MOONEY AIRCRAFT, INC.
KERRVILLE, TEXAS

SERVICE LETTER 20-79
(This Service Letter is FAA approved)

DATE: February 1, 1961

SUBJECT: Installation of Carburetor Air Box Spacer
P/N 6396.

FIGURE 1
INSTALLATION OF CARBURETOR AND AIR BOX SPACER.

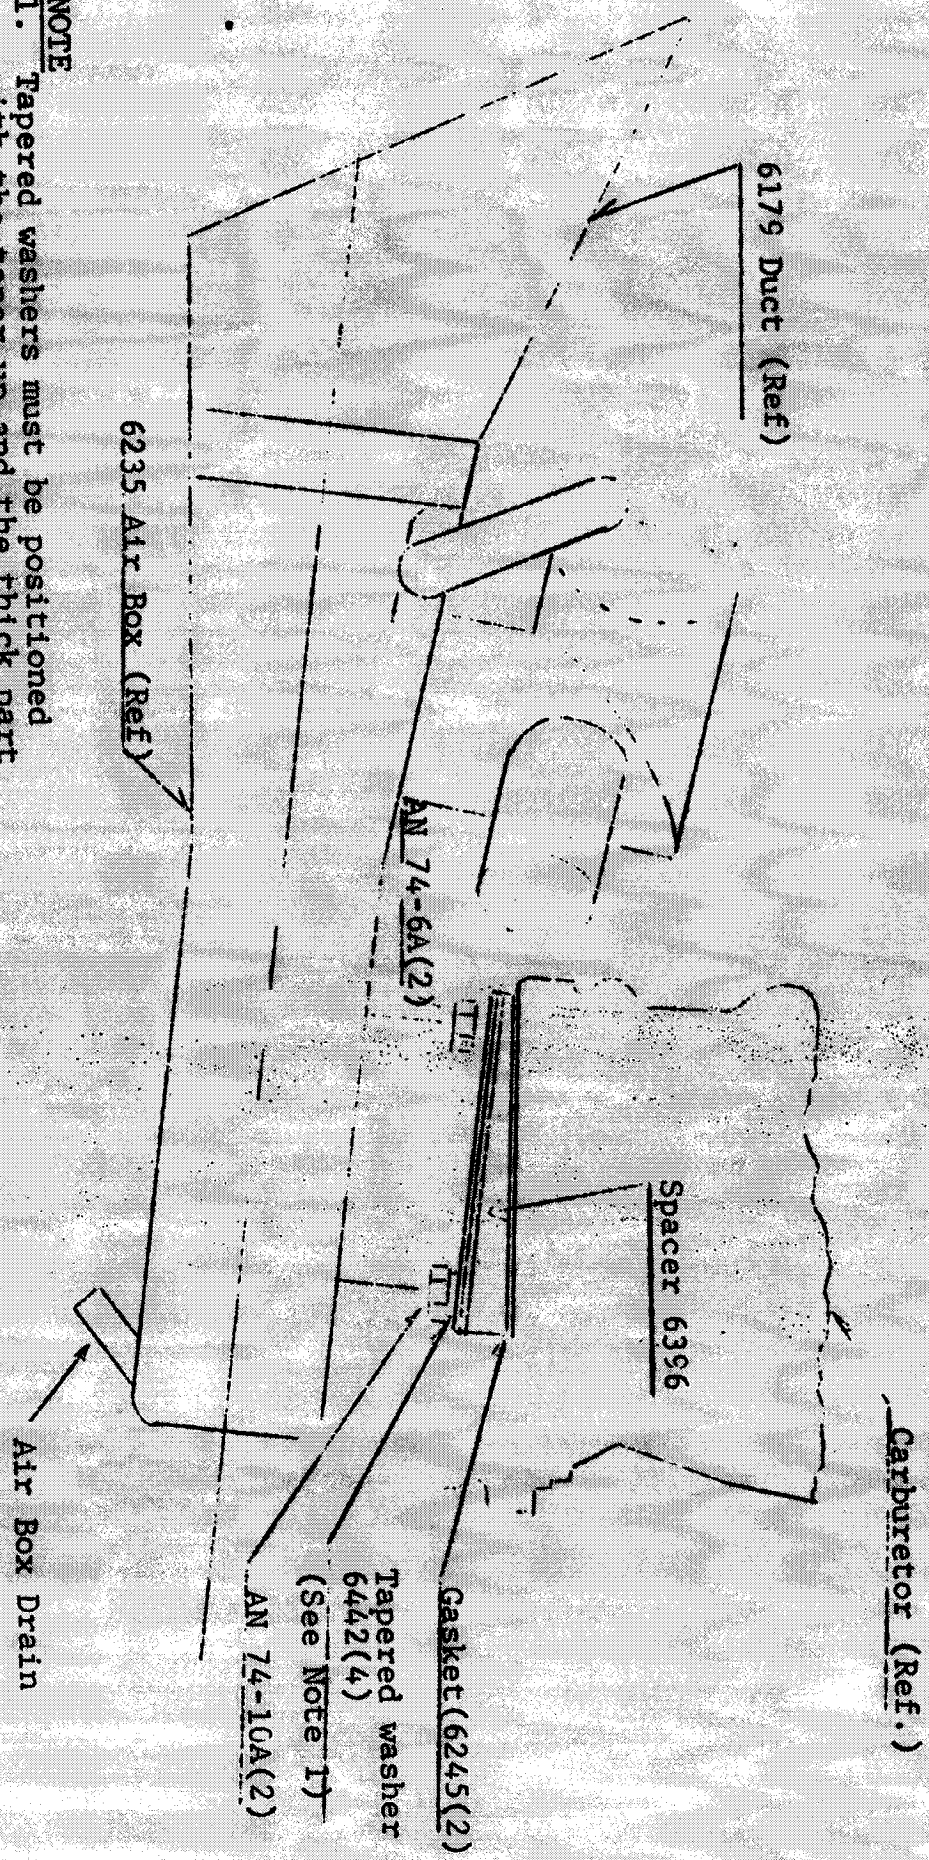
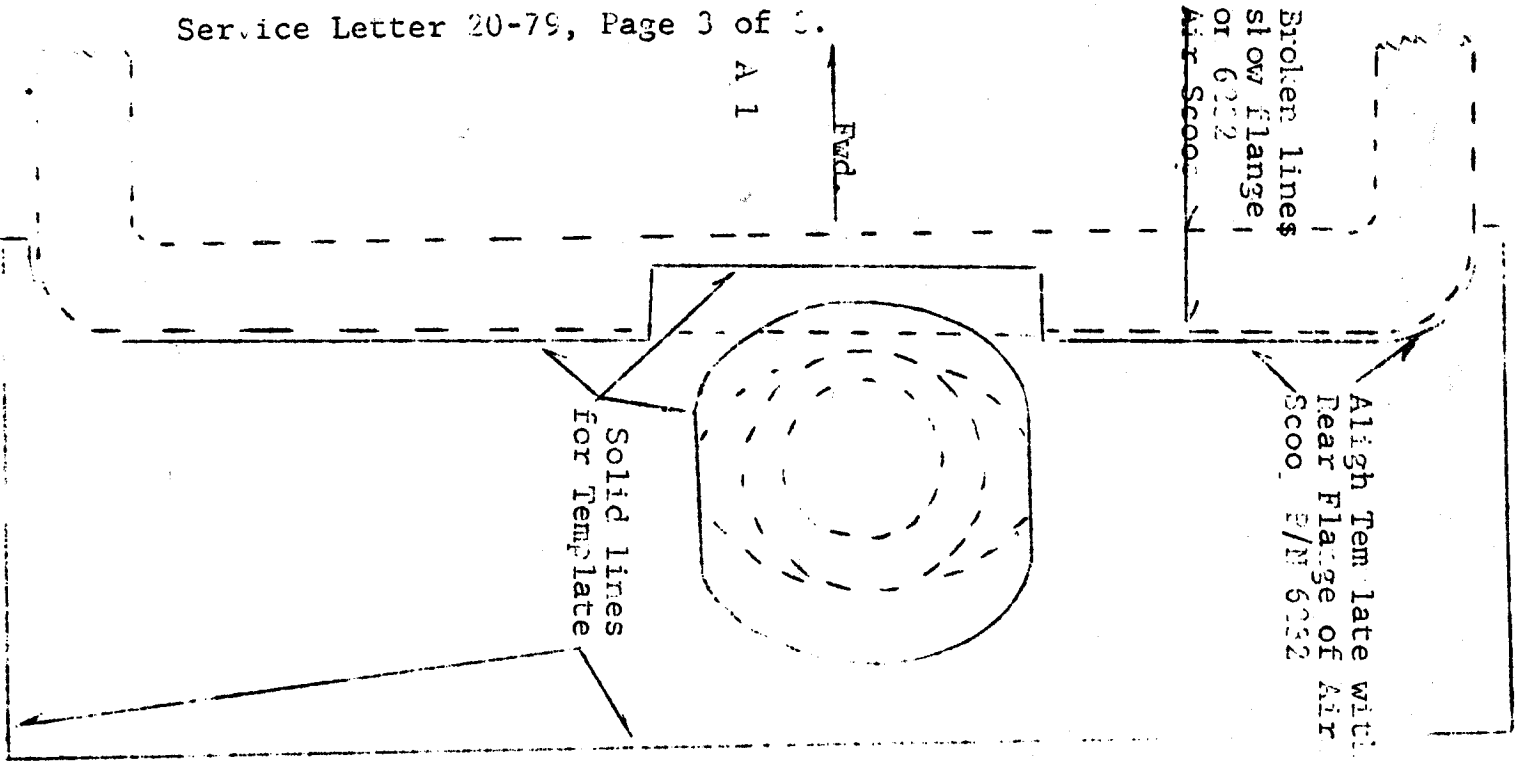
The service life of the carburetor air duct (p/n 6179) can be improved by the installation of a spacer. In order to increase the duct service life, a spacer is now available for installation between the carburetor and the carburetor air intake box to provide additional clearance between the duct and the lower engine cowling.

1. Install Spacer p/n 6396 as shown in figure 1.
2. Make template by attaching Figure 2 on cardboard or other suitable material.
3. Place template against outside of lower cowling and mark and cut out hole.
4. Modify grommet and install as shown in Figure 2, detail A and B.

NOTE
1. Tapered washers must be positioned with the taper up and the thick part forward as shown.

FIGURE 2

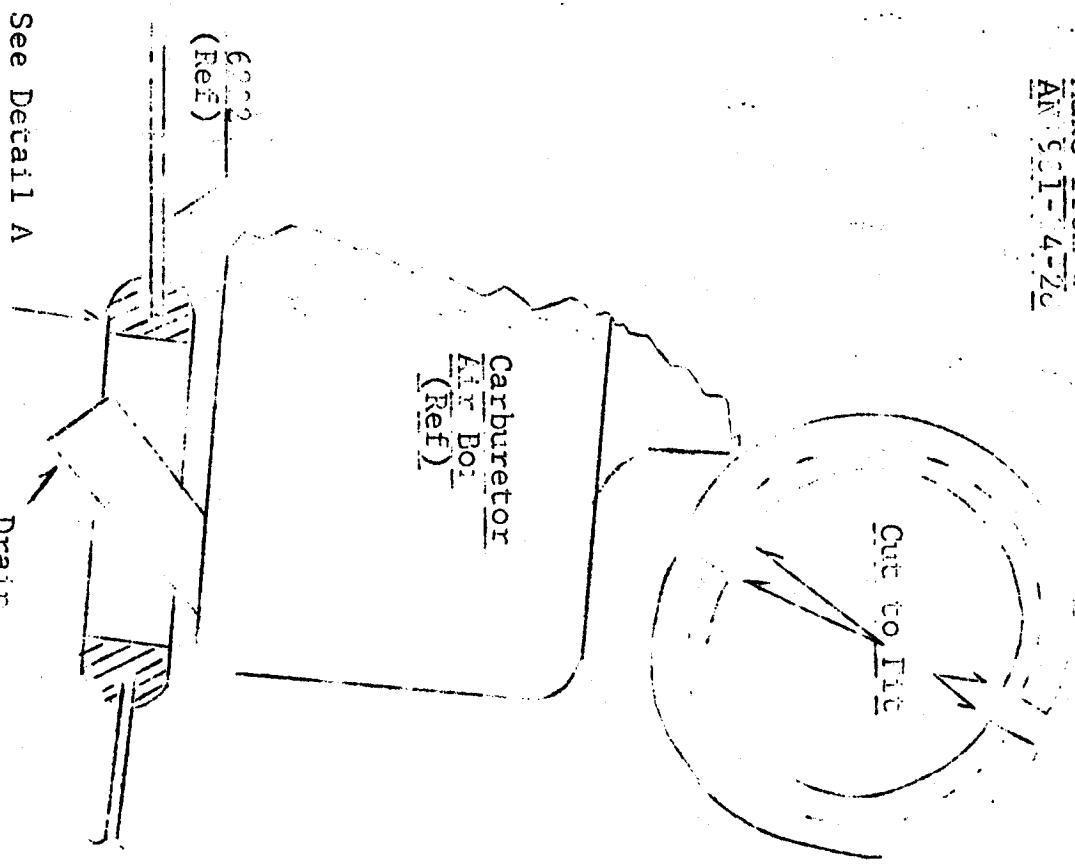
CAUTION - Carburetor Air Boi. Drain Tube should clear hole in Cowling a minimum of 1/2"

Detail A
 Make from
 AN 501-4-20
